**ADDENDUM NO. 1
TO PLANS AND SPECIFICATIONS FOR THE
ALPENA WATER PRODUCTION PLANT (WPP) CLEARWELL REPLACEMENT
& INFRASTRUCTURE IMPROVEMENTS**

ISSUED: March 1, 2024

HRC Job No. 20220751

STRUCTURAL FOUNDATION PLAN

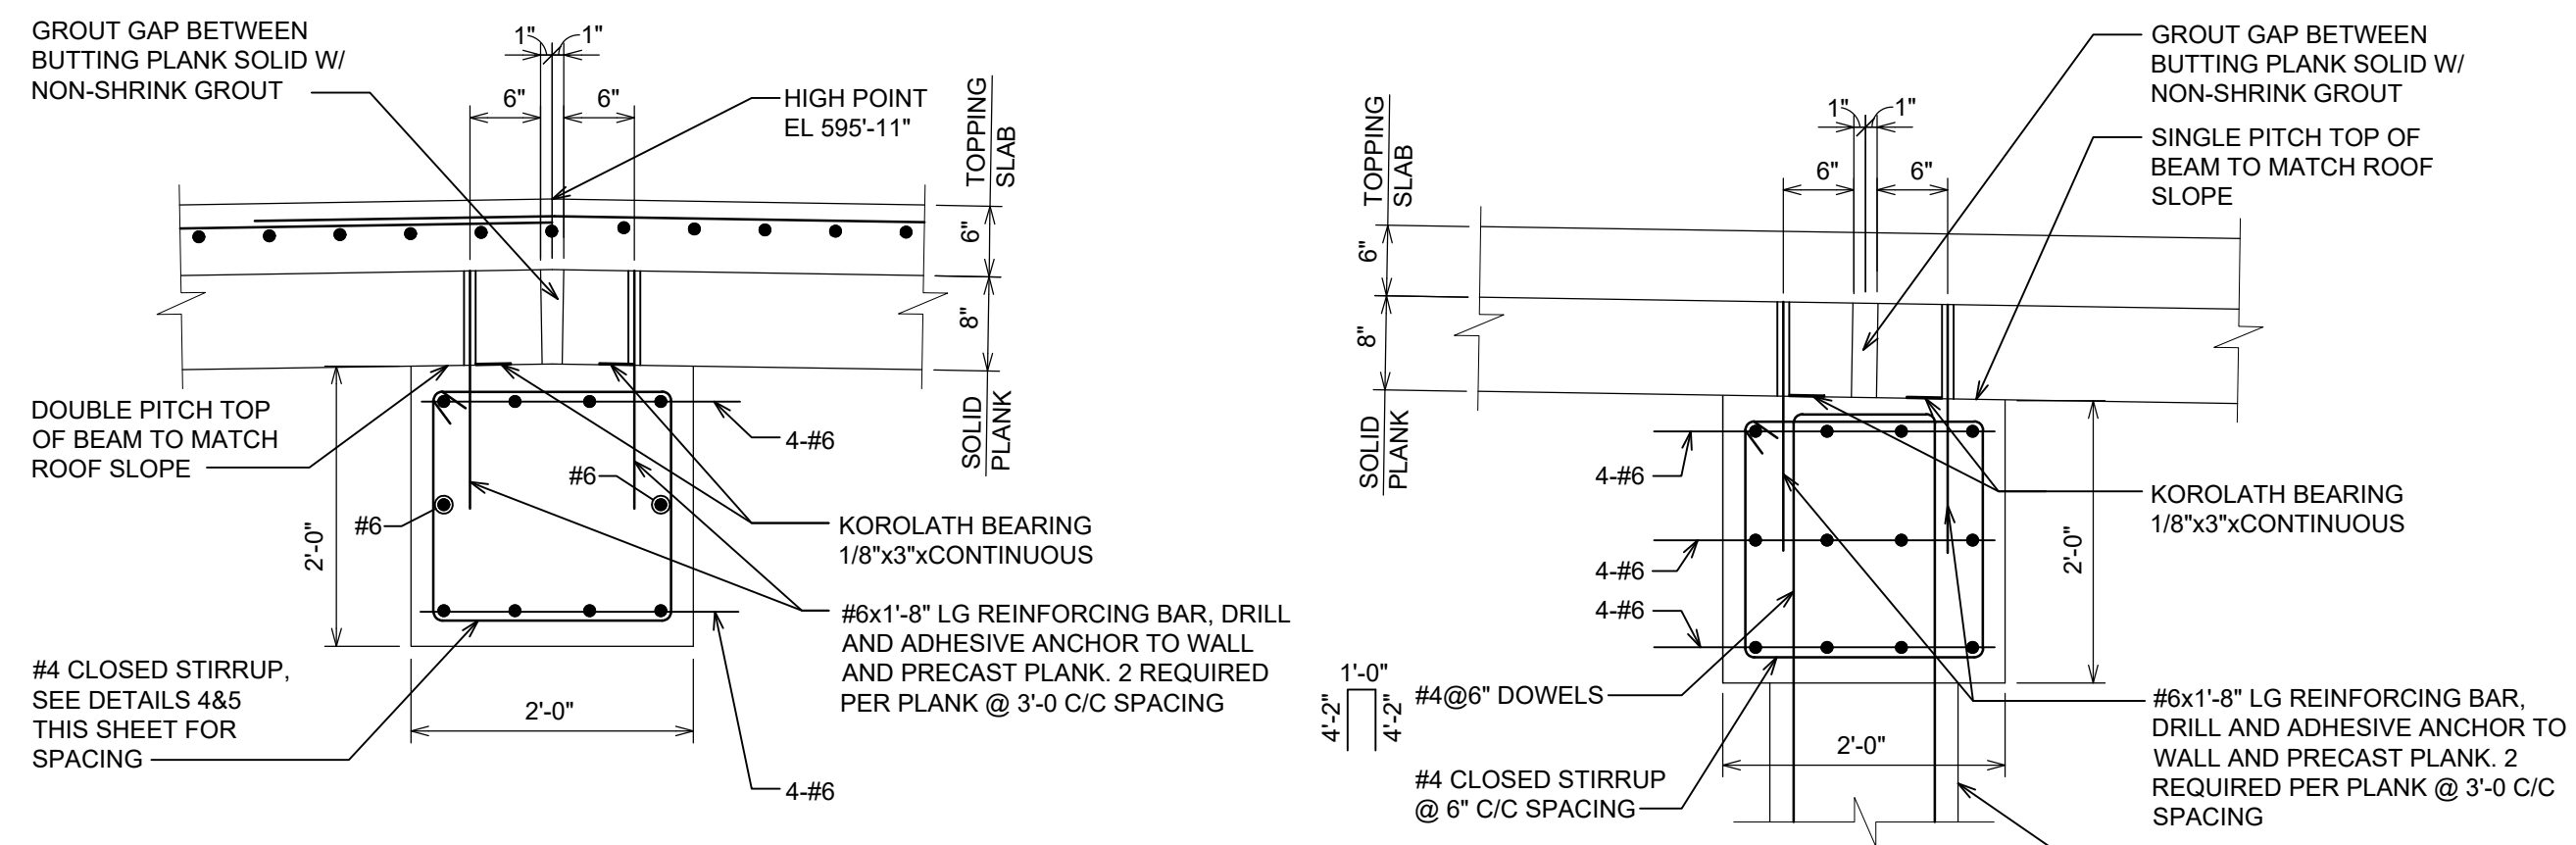
- d. Q - I am unclear as to what will be allowed for demolition of the old clearwell top and walls. Are you expecting no hydraulic hammering during demolition or could we get the existing tanks cut loose from the existing building and use a hammer to break the rest of them up?

- i. HRC Response – Refer to the demolition Key Notes on Sheet S-2. In Notes 11 and 18 for example, we state to cut the tops slab lose and move pieces away from the existing structure before breaking them up. We are not saying that hydraulic hammering is not allowed, you just cannot break up the concrete until you've moved the pieces away from the existing structure. If you use hydraulic hammering (or other means) and those activities cause excessive vibration, exceeding the baseline specified, then you will be required to change your demolition means and methods at no additional cost to the Owner.
